AMENDED REGIONAL INTERESTS DEVELOPMENT APPROVAL (RIDA) ~~21 February 2019~~ 16 June 2020

RPI18/013 – Lynd Resources Pty Ltd (ACN 610 450 498)
C/- Ardent Group Pty Ltd (ACN 604 696 764) - Huari Project.

This amended development approval authorises impacts on the Gulf Rivers Strategic Environmental Area by the approved activities. Deletions are shown as strike through, whilst additions are shown in bold italic font.

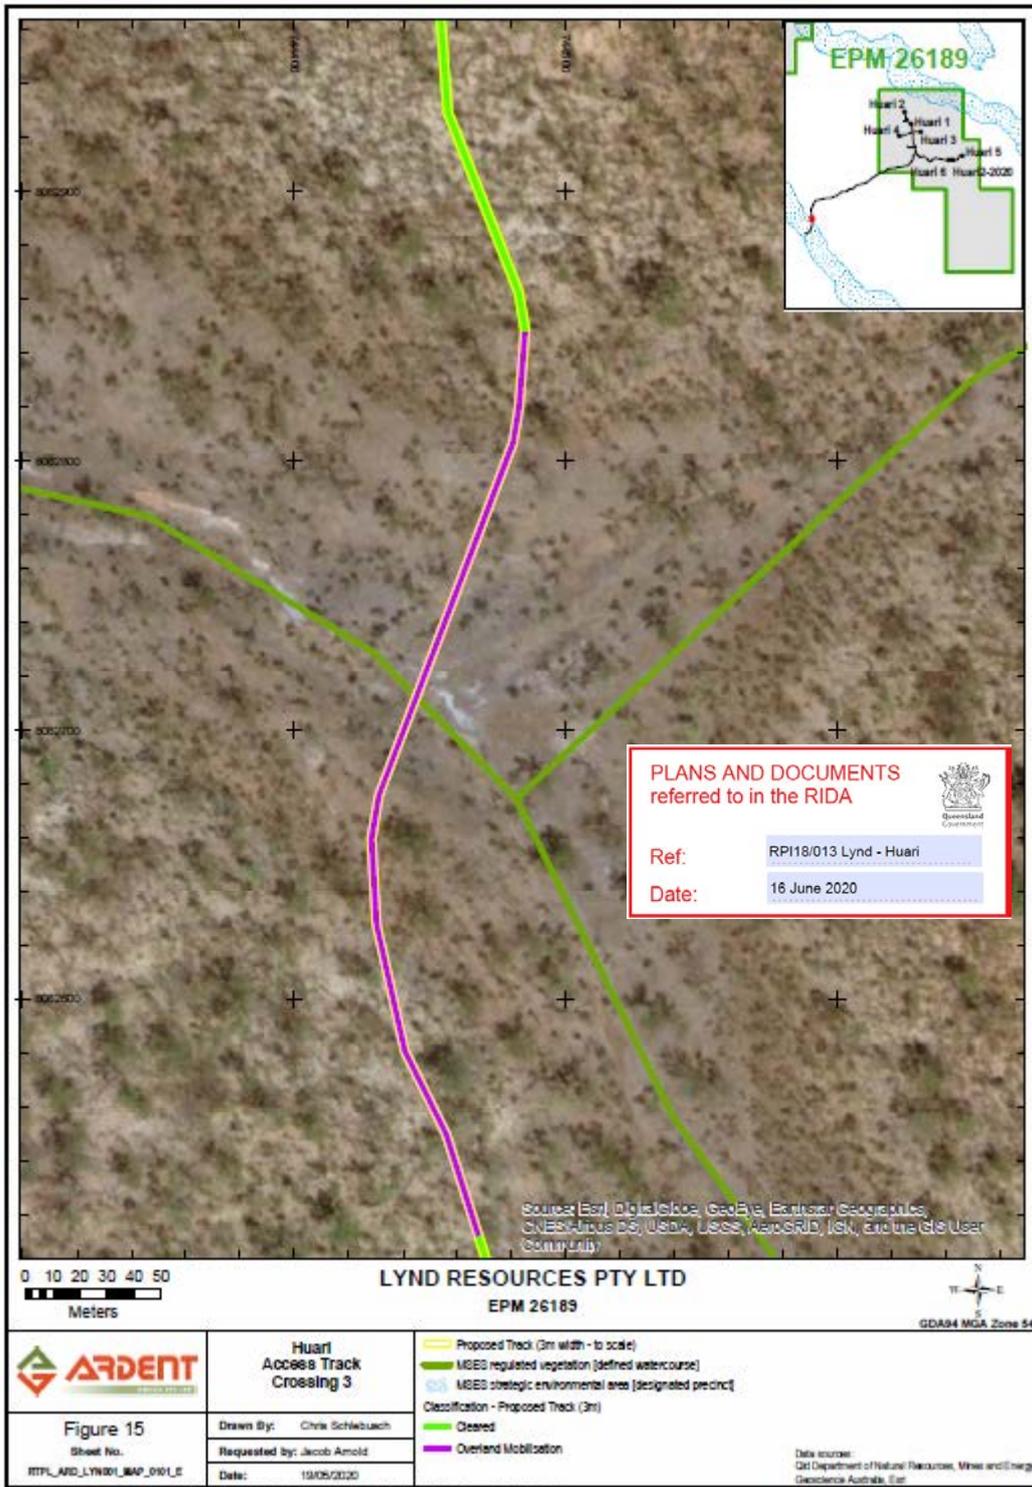
<p>vegetation crossing 2, Sheet No. ADMG_ARD_LYN001_MAP_0100_C, dated 8/01/19, as provided by the applicant and lodged with the amendment application on 25 January 2019 (refer Attachment 1);</p> <p>Figure 14: Huari Access Track Crossing 2, Sheet No. RTPL_ARD_LYN001_MAP_0100_D, dated 1/05/2020 (refer Attachment 1);</p> <ul style="list-style-type: none"> • Figure 15: Huari access track regulated vegetation crossing 3, Sheet No. RTPL_ARD_LYN001_MAP_0101_D, dated 1/05/20, as provided by the applicant and lodged with the amendment application on 29 May 2020 (refer Attachment 1); <p>Figure 15: Huari Access Track Crossing 3, Sheet No. RTPL_ARD_LYN001_MAP_0101_E, dated 1/05/20 (refer Attachment 1);</p> <ul style="list-style-type: none"> • Figure 16: Huari access track regulated vegetation crossing 4, Sheet No. ADMG_ARD_LYN001_MAP_0102_C, dated 8/01/19, as provided by the applicant and lodged with the amendment application on 25 January 2019 (refer Attachment 1); <p>Figure 16: Huari Access Track Crossing 4, Sheet No. RTPL_ARD_LYN001_MAP_0102_D, dated 1/05/2020 (refer Attachment 1);</p> <ul style="list-style-type: none"> • Figure 17: Huari access track regulated vegetation crossing 5, Sheet No. ADMG_ARD_LYN001_MAP_0103_C, dated 8/01/19, as provided by the applicant and lodged with the amendment application on 25 January 2019 (refer Attachment 1); <p>Figure 17: Huari Access Track Crossing 5, Sheet No. RTPL_ARD_LYN001_MAP_0103_D, dated 1/05/2020 (refer Attachment 1);</p> <ul style="list-style-type: none"> • Figure 18: Huari Access Track Crossing 5, Sheet No. RTPL_ARD_LYN001_MAP_0104_E dated 19/05/2020 (refer Attachment 1); • Figure 19: Huari access track regulated vegetation crossing 7, Sheet No. ADMG_ARD_LYN001_MAP_0105_C, as provided by the applicant and lodged with the amendment application on 25 January 2019 (refer Attachment 1); <p>Figure 19: Huari Access Track Crossing 7, Sheet No. RTPL_ARD_LYN001_MAP_0105_D, dated 1/05/2020 (refer Attachment 1);</p> <ul style="list-style-type: none"> • Figure 20: Huari access track regulated
